**Re: 38 Morse Street (32-38 Morse Street); Addition of 2-units
AMENDMENT**

**Re: Application ID: # 2008-0064
Original Site Plan Approval dated September 28, 2009
CBL: 163 A015 001 and 163A A016 001**

On March 18, 2010, the Portland Planning Authority approved the amended site plan for the proposal to add 2 units (to create a multiplex) at 32-38 Morse Street, as shown in the approved plans prepared by Owen Haskell, Inc (Site Plan 02.16.2010 and Site Details Rev 6 09.18.09) and by Michael F. Hays Architect (Building Plans A1-A7 all dated 02.15.2010) with the following conditions:

To: Barbara Barhydt
Jean Fraser
From: David Margolis-Pineo
Public Services Review Comments
Re: 38 Morse Street

TYPICAL PIPE TRENCH INSTALLATION AND NOTES

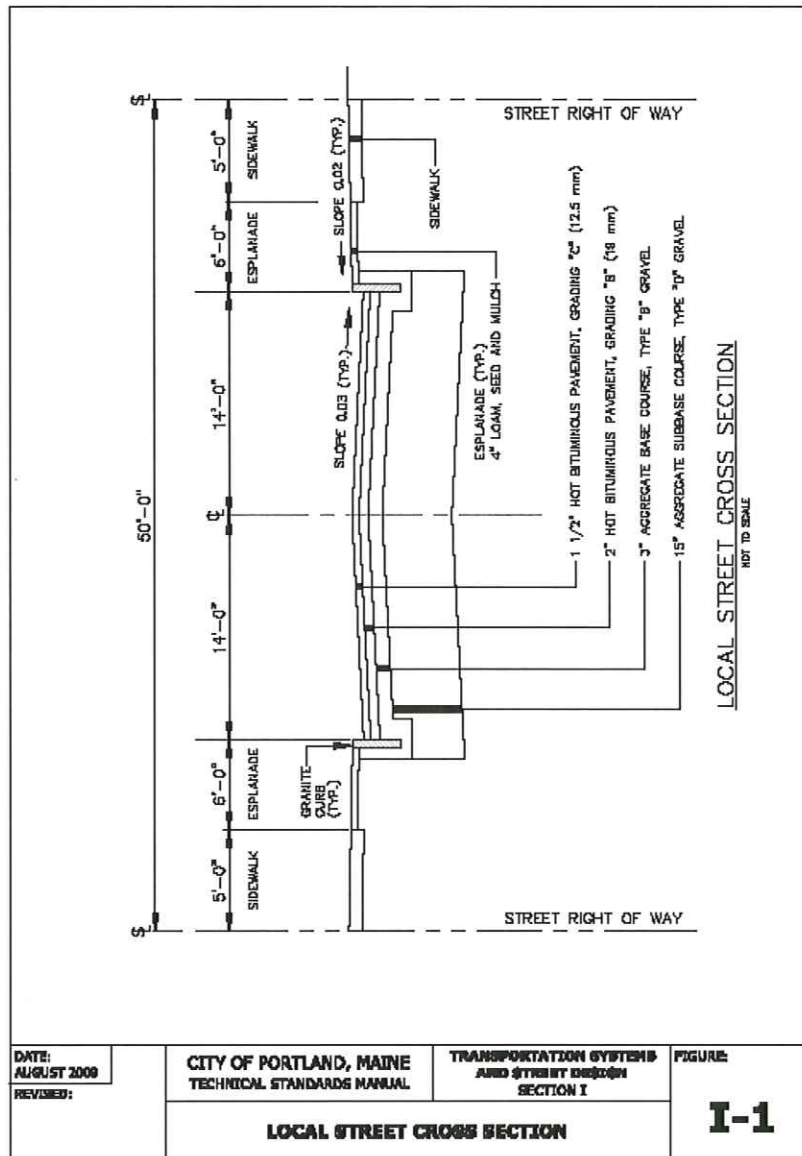
1. The applicant's site plan currently shows granular bedding under the sewer pipe to be installed in the street. This detail is incorrect. Please use the following details for utility bedding and street repair when excavation with the Morse Street right of way. Thank you.

NEW
SECOND FLOOR CONCEPT

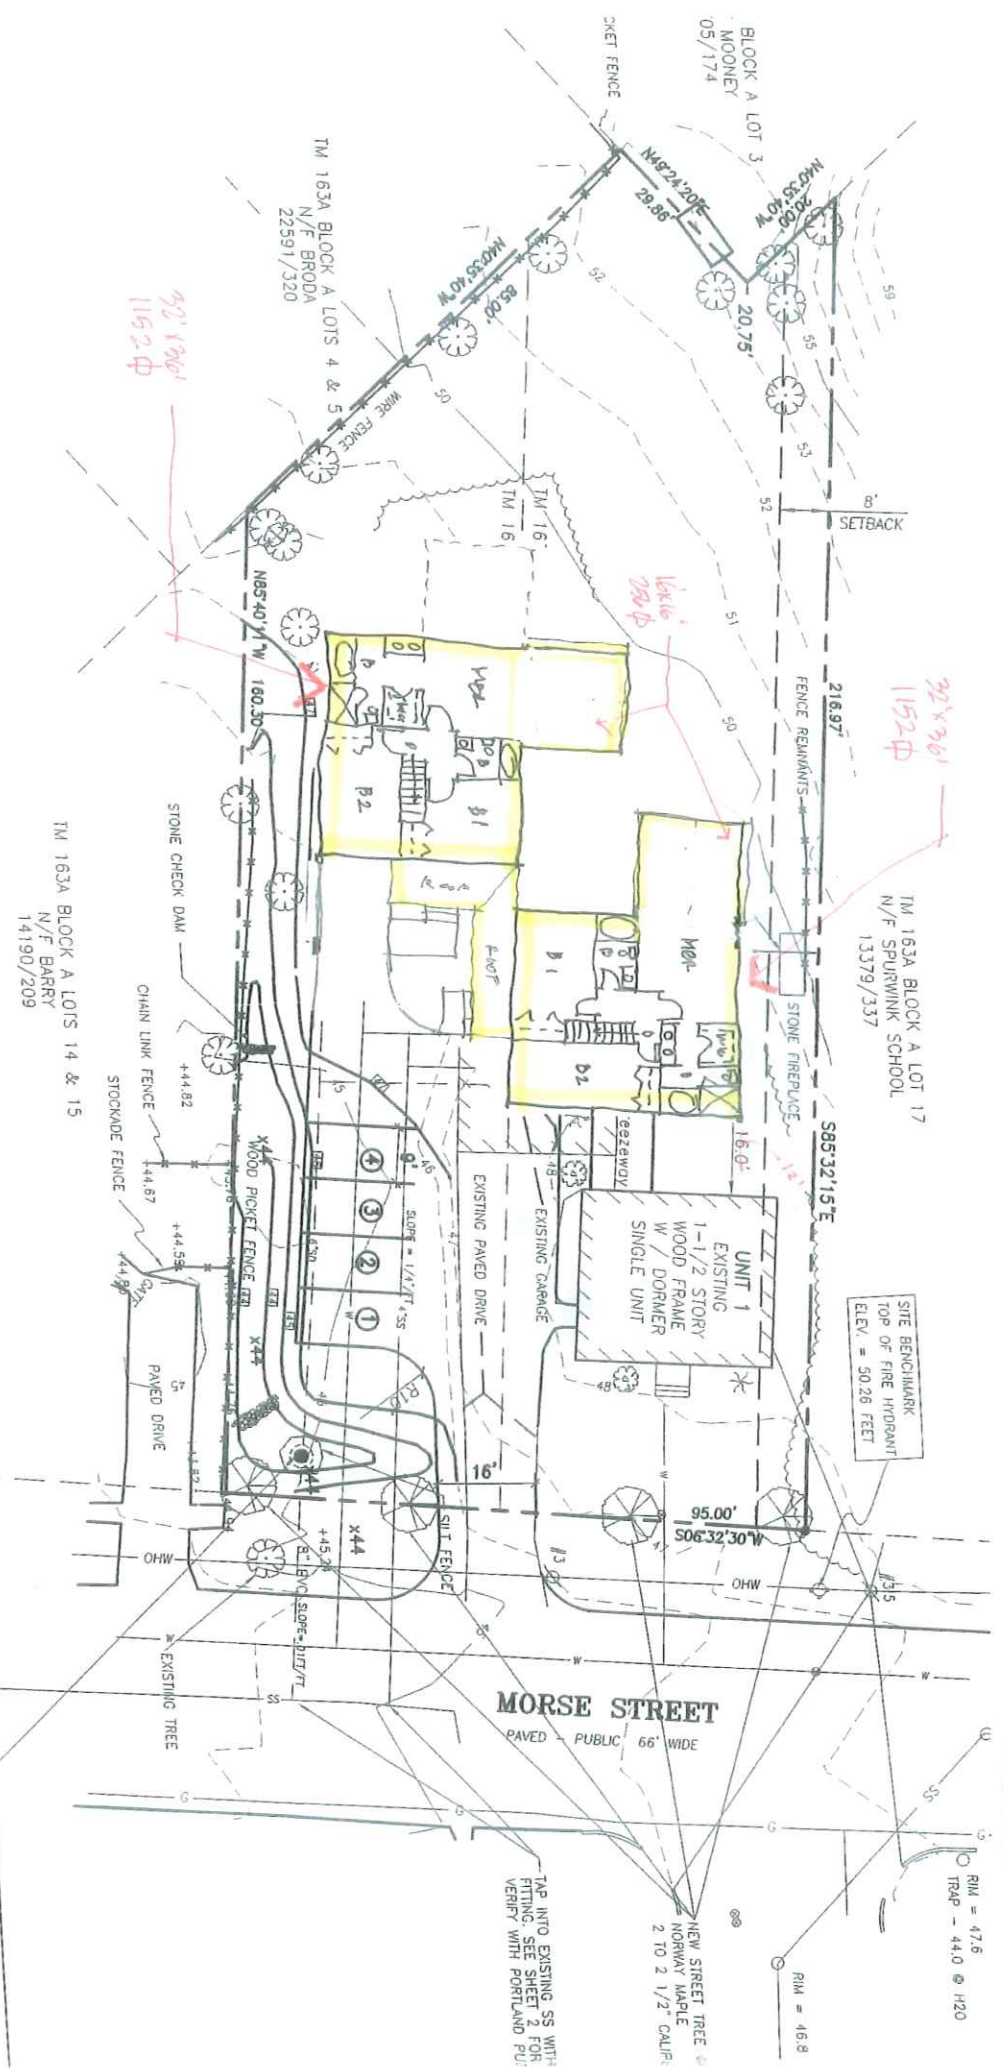
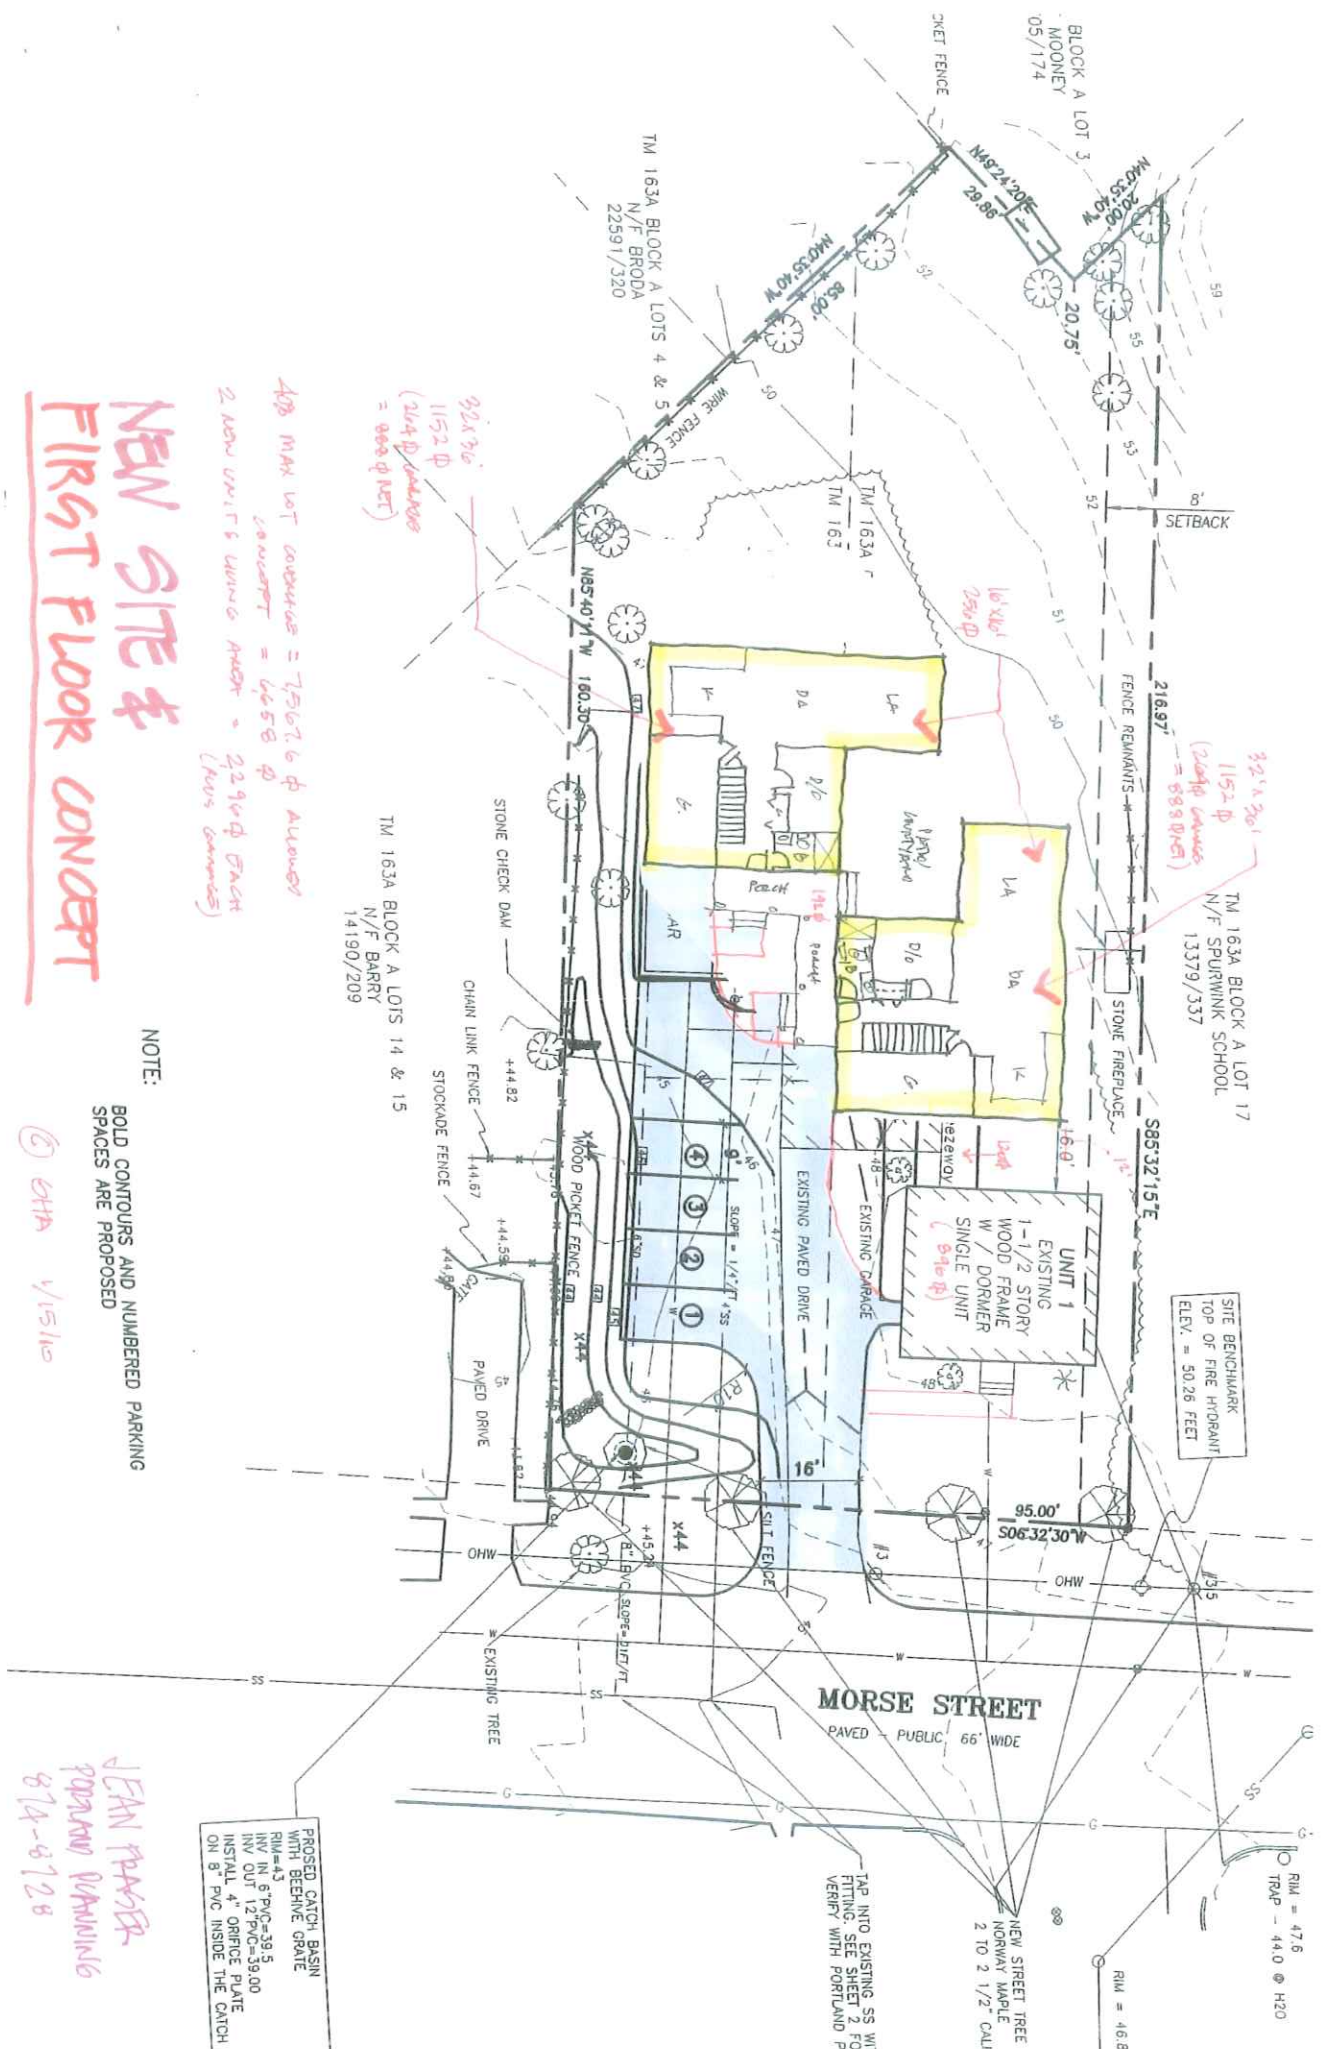
- ① SF conveyed questions re breezeway + porch foundations
as raised at Dev Rev + Mike will ensure clarified in plans
- ② SF noted increase in impervious surface and while
may still be within zoning there is concern over even
more pavement at front. Suggested a clear landscape
Plan (or Site Plan with clear landscape proposals) be
included and add in more areas of permeous/landscaped,
more screening of parking / front paved area, and
confirm that trees at rear boundary to be retained.

- ③ Cover letter to clarify (+ keep as narrow as poss)
what changed between approved scheme + current
scheme + comparison re zoning dimensions (setback,
height, impervious coverage).

- ④ Mike confirmed:
 - a) Owen Haskell to prepare Site Plan w/ his (MH)
arch planner etc
imp as background
 - b) Mike to prepare cover letter + be point of contact

- c) He will convey comments re landscape
 - d) will prepare Site Plan application - knows
it's an amendment w/ fee + address some

Barbara confirms
need amend. appl cation
B250
